**Re: Cold Brook Crossing
Stormwater Management Peer Review
Response to Comments**

Civil Design Group, LLC (CDG) is in receipt of The Horsley Witten Group's (HW's) review letter, dated April 17, 2020, for the above-referenced project. Our responses are provided below in **bold** following each of HW's comments, and supporting plans and documents are enclosed herein:

Subcatchment PR-3B:

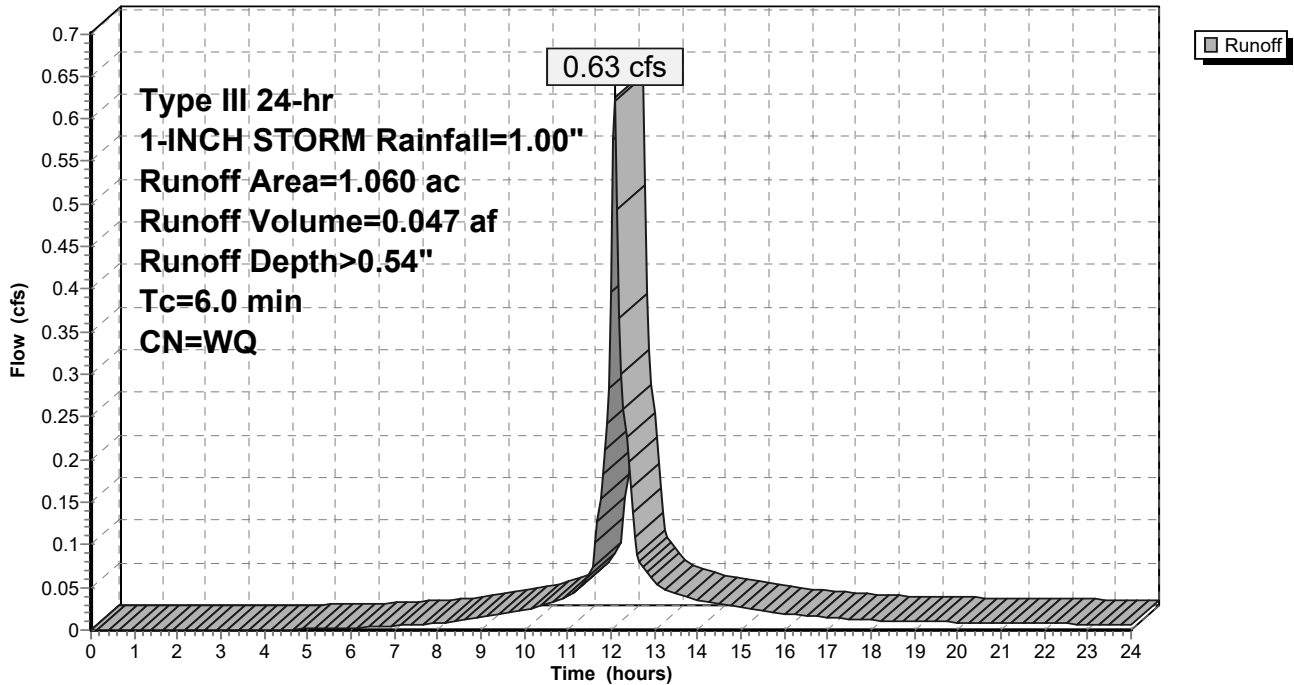
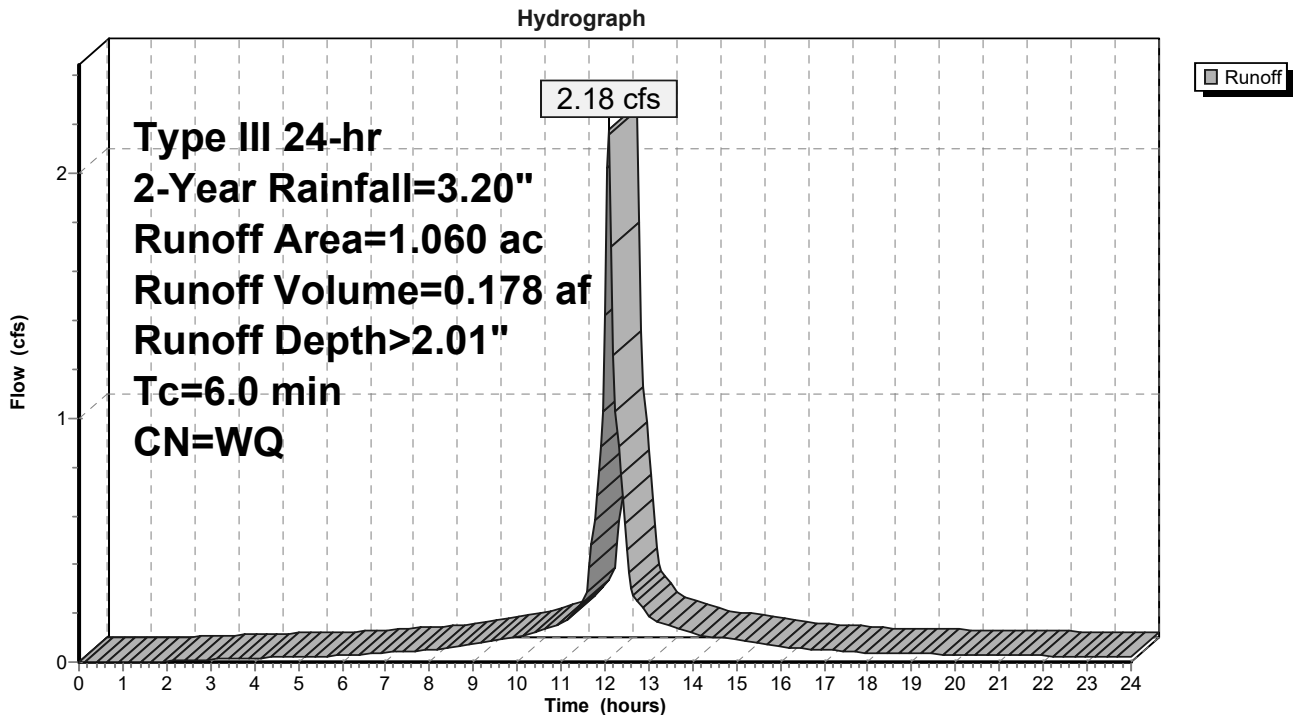
- a. There appears to be some inconsistency between the proposed HydroCAD analysis, and the areas illustrated on the Post-Development Watersheds, Figure 4. HW was not able to confirm the watershed areas provided for some of the watershed areas and recommends that the Applicant revisit the watershed plan and HydroCAD model to confirm that the areas modeled are accurate. HW recommends that the Applicant confirm the following areas:

- Subcatchment PR-3B
- Subcatchment PR-3D
- Subcatchment PR-3G
- Subcatchment PR-3I

CDG has calculated the watershed areas in AutoCAD and made minor adjustments to the watershed areas listed above. Updated HydroCad modeling output for these watersheds is included in Attachment 1.

Pond SIS-3:

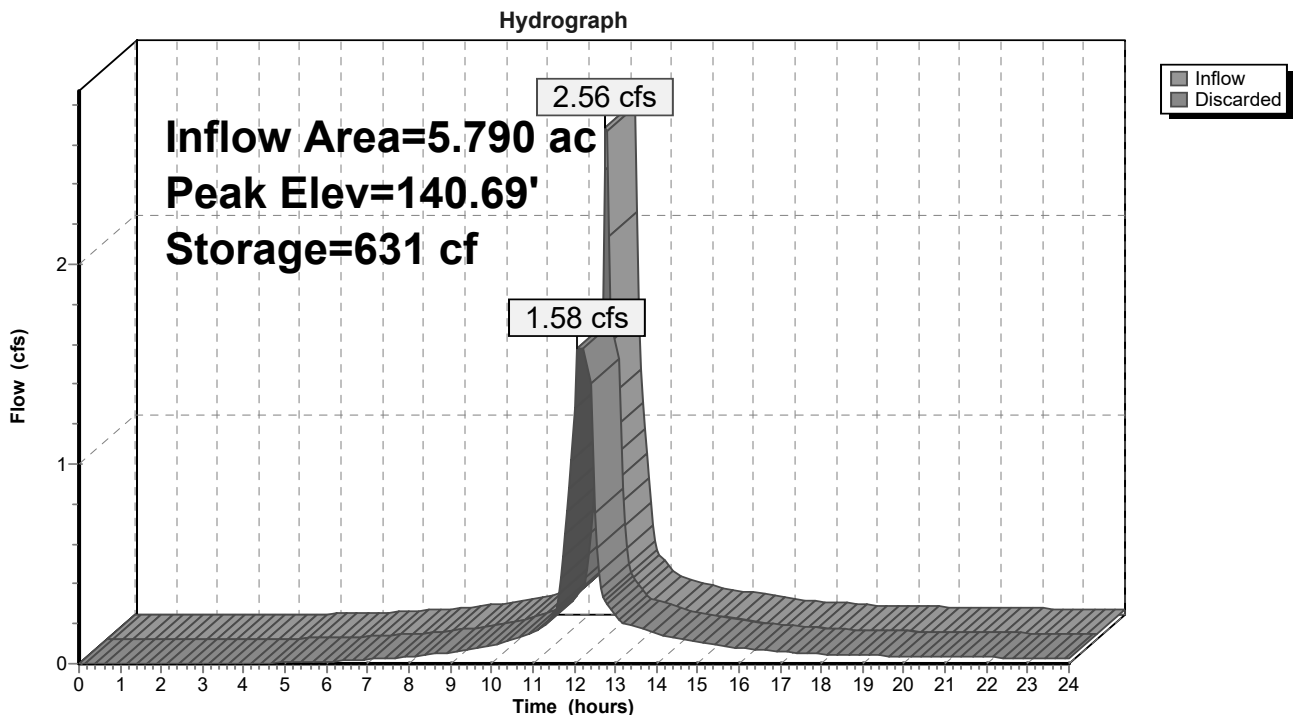
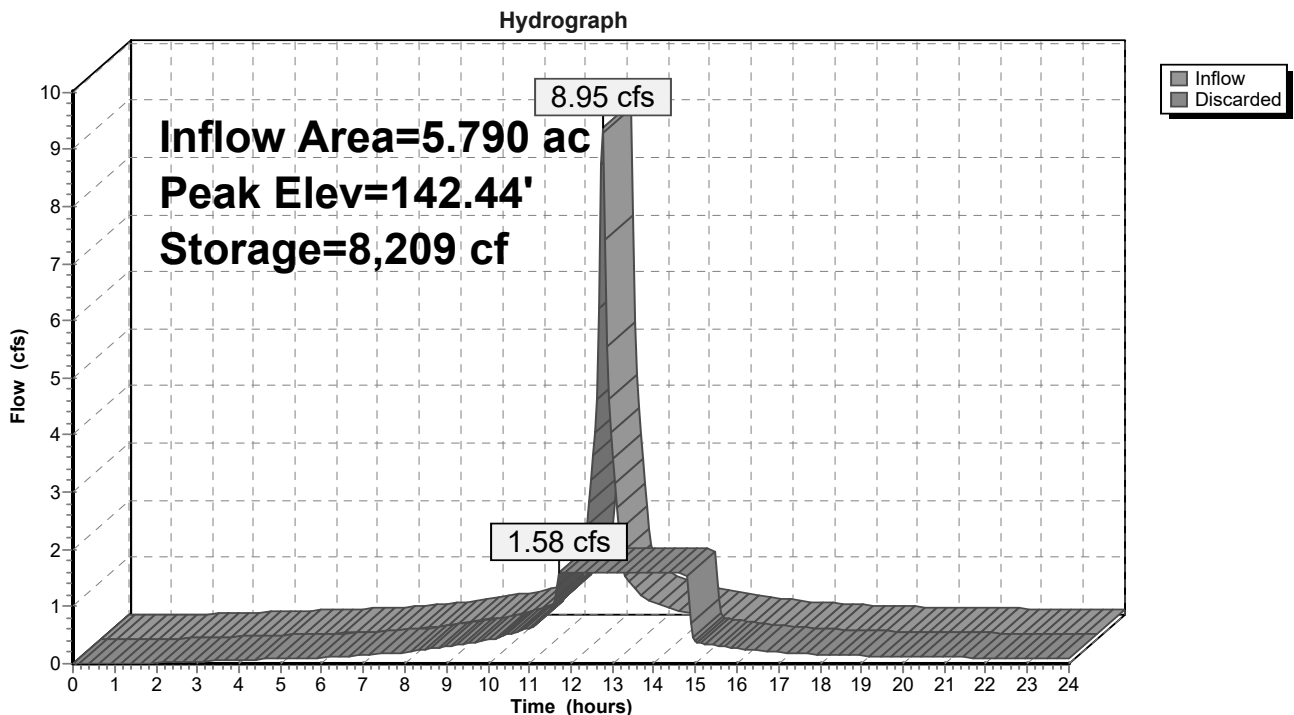
Furthermore, HW recommends that the Applicant confirm that the following subsurface infiltration systems have been sized to manage the applicable watershed area.

- Pond-SIS-10
- Pond-SIS-7
- Pond-SIS-4
- Pond-SIS-3

Based on the watershed adjustments noted above, CDG has made minor revisions to SIS-3 and SIS-7. No revisions were necessary for SIS-4 and SIS-10. Updated HydroCad modeling output for these watersheds is included in Attachment 1. Updated versions of the details entitled “Subsurface Infiltration System (SIS) Dimensions” and “Subsurface Infiltration System (SIS) Detail” are included in Attachment 2. These updated details will be incorporated into the plan set at the completion of the peer review.

SUBSURFACE INFILTRATION SYSTEM (SIS) DETAIL

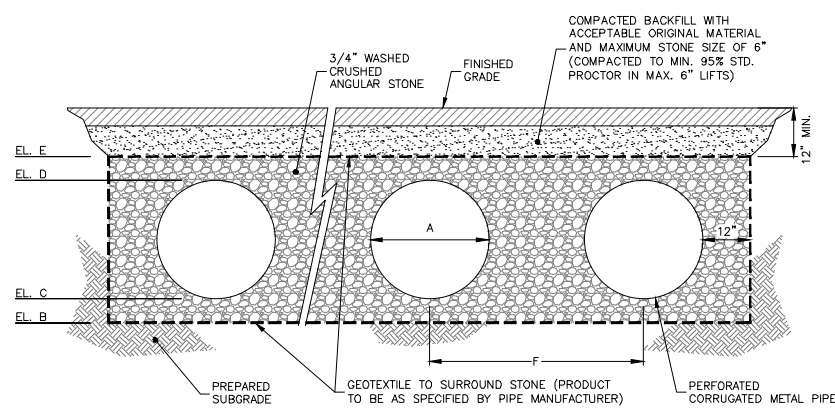
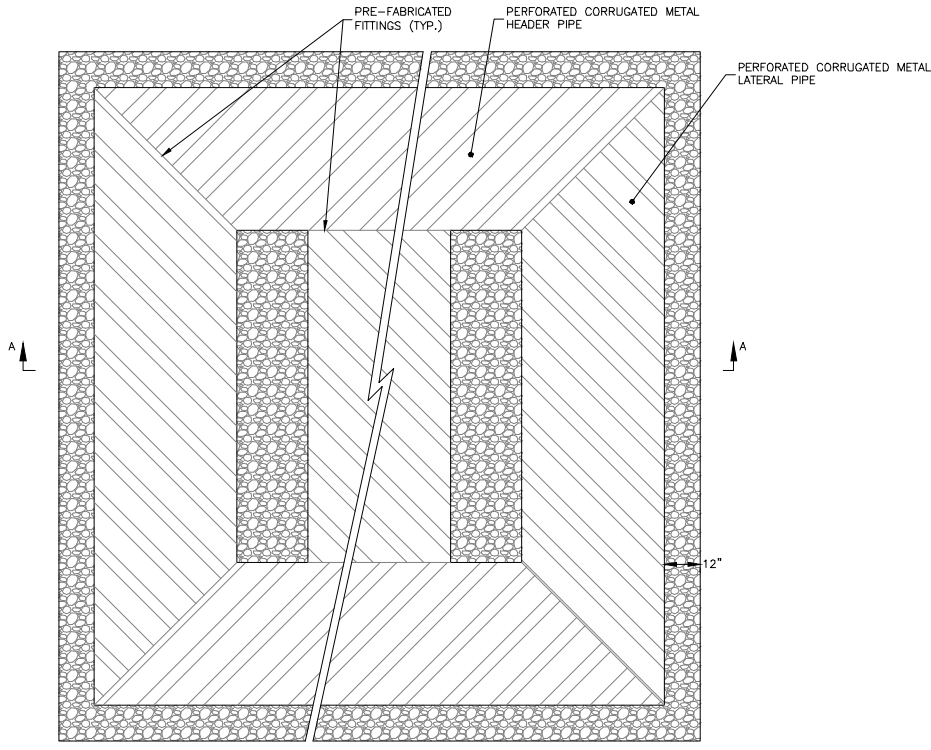
- g. The Applicant provided a Subsurface Infiltration System (SIS) detail on Sheet 29 of the Site plans. The SIS detail does not indicate the width of stone to be placed around the system. HW recommends that the Applicant add the width of stone required to the detail.

- d. HW recommends that the Applicant provide additional notes regarding the avoidance of heavy equipment over the infiltration chambers areas.

The width of stone around the edges of the SIS systems is proposed to be 12". The referenced detail (Attachment 2) has been updated to include this dimension. This updated detail will be incorporated into the plan set at the completion of the peer review.

A note has been added to the “Subsurface Infiltration System (SIS) Detail” (Attachment 2) requiring the limits of the SIS systems to be delineated and the use of heavy equipment to be avoided in those areas. This updated detail will be incorporated into the plan set at the completion of the peer review.

SIS-6 SECTION A-A

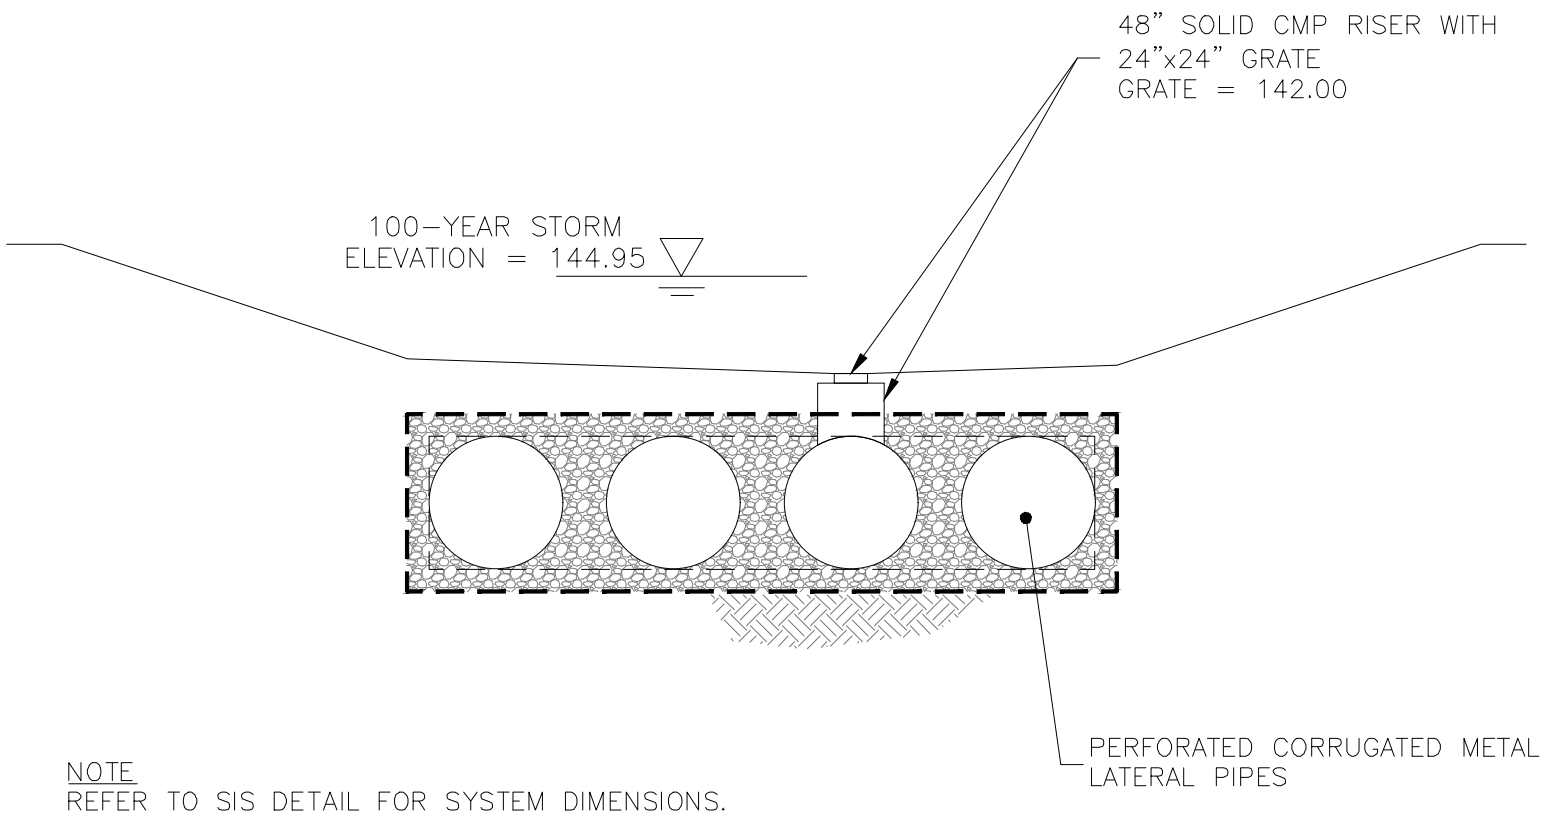
- e. SIS-6 includes a riser that allows the stormwater to overtop the system into a grass depression directly above it. The depression will contain stormwater during the larger storm events. HW recommends that the Applicant provide an additional detail clarifying how the riser is connected to the subsurface system.

A new detail entitled “SIS-6 Section A-A” has been created to clarify how the riser system will connect to the SIS and is included in Attachment 2. This detail will be incorporated into the plan set at the completion of the peer review.

TYPICAL SILT SACK DETAIL

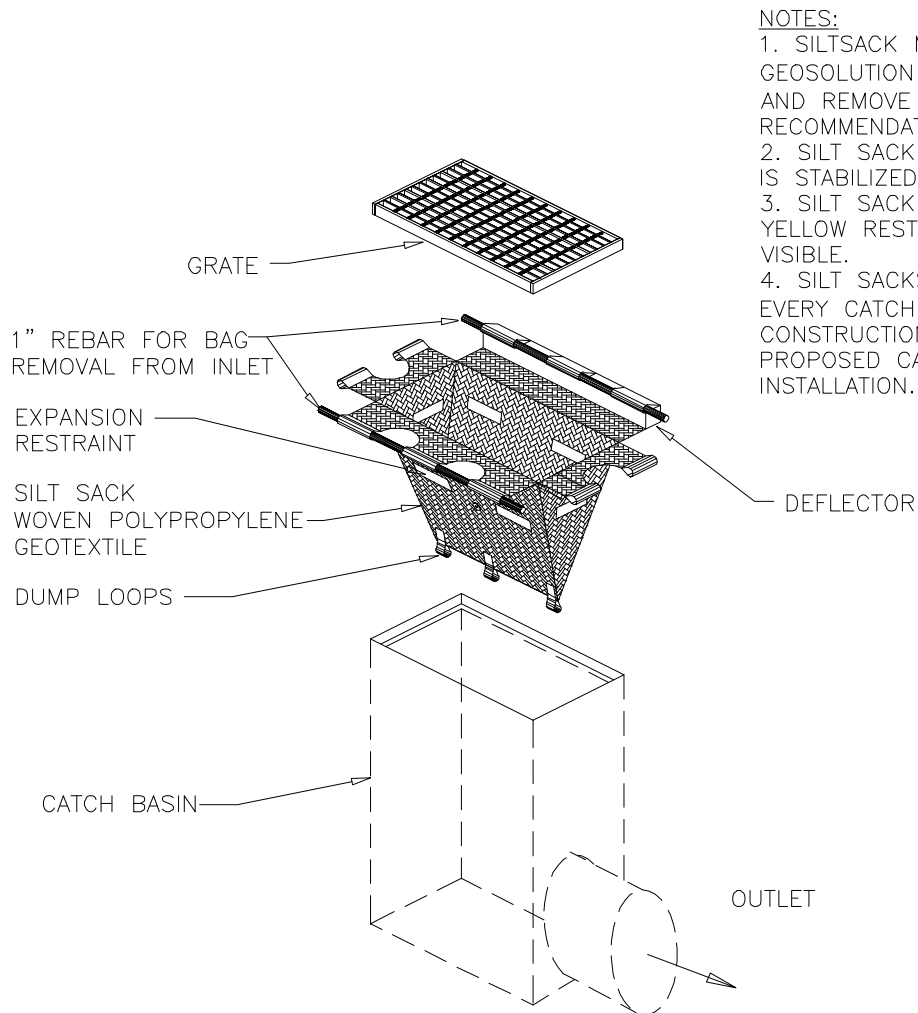
- a. HW recommends that, if applicable, the Applicant provide inlet protection on every catch basin within 100 feet of the construction entrance. Furthermore, HW recommends that inlet protection is provided on each proposed catch basin when the grate is installed.

The "Silt Sack Detail" (Attachment 4) has been updated to require inlet protection on every catch basin within 100' of the construction entrance and on proposed catch basins upon installation. This updated detail will be incorporated into the plan set at the completion of the peer review.
